Ein cyf/Our ref: CAS-184473-V4Y3 Eich cyf/Your ref: 2021/01082/1/CD

BWRIAD / PROPOSAL: DISCHARGE OF CONDITION 3 (FLOOD CONSEQUENCE ASSESSMENT) OF PLANNING APPROVAL 2021/01082/RG3 FOR A FLOOD **ALLEVIATION SCHEME FOR LLANMAES VILLAGE**

LLEOLIAD / LOCATION: LLANMAES, LLANTWIT MAJOR, VALE OF GLAMORGAN

Figure 3-4: Proposed Development

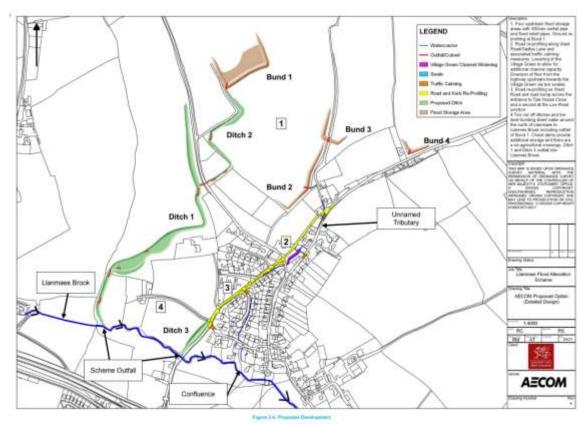
However, the scheme is shown to increase flood depths in the surrounding agricultural fields as a result of the proposed bunds and storage areas. To mitigate flood risk to the village the scheme involves constructing bunds and ditches as shown in Figure 3-4 of the FCA (repeated below) that will intercept and hold the water before being discharged into the Llanmaes Brook. The areas where there is shown to be an increase in flood depths are the fields where the run-off of water collects and then flows into Llanmaes village via overland flood flow routes. As can be seen from Figure 7-1 (below) the predicted flood depths within the Village are reduced and the flood depths at the location of the proposal increase.

Figure 7-1 Depth Difference Map Proposed Option vs Baseline 1% AEP + 30% climate change.

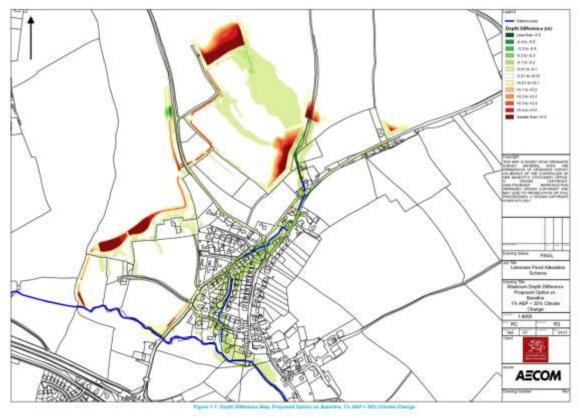
TAN15 includes acceptability criteria which states 'no increase in flooding elsewhere' (Section 9 TAN15 (2004)). However, no further guidance on how this should be assessed is provided within the TAN.

As the proposal objective is to seek to reduce flood risk to residential properties, we advise the planning authority uses the above information to determine whether the predicted consequences of flooding are acceptable, balancing other material planning considerations in your decision making. If you are satisfied with the above, we have no objection to you discharging condition 3 of planning approval 2021/01082/RG3. If you require further technical guidance on the risks and consequences of flooding to aid your decision making, please contact us.
